Engineering Change Notice (ECN)

Due to add an I2C interface to the original PA1010D module, the new version have launched and the original(v.01) PA1010D module will not be manufactured anymore. Instead, CDTop will make a pin location change on the new(v.02) PA1010D module. This ECN will compare the differences in characteristics and other related specifications between the new PA1010D module and the original one.

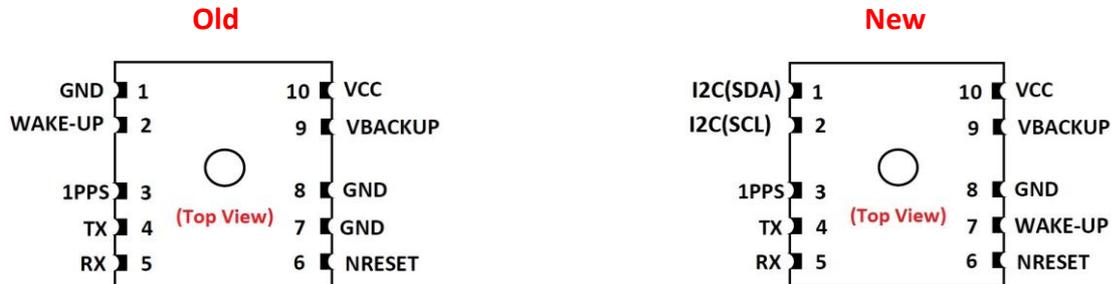
1. **Pin location:**

a. The new one has a **I2C** interface on the pin 1 & 2. The pin1 is defined to **I2C_SDA**, it outputs GPS information for I2C application, keep floating if not used. Pin 2 is defined to **I2C_SCL**, it is used to received the clock for I2C application, keep floating if not used.

b. The **WAKE-UP** pin shift from pin2 to pin 7.
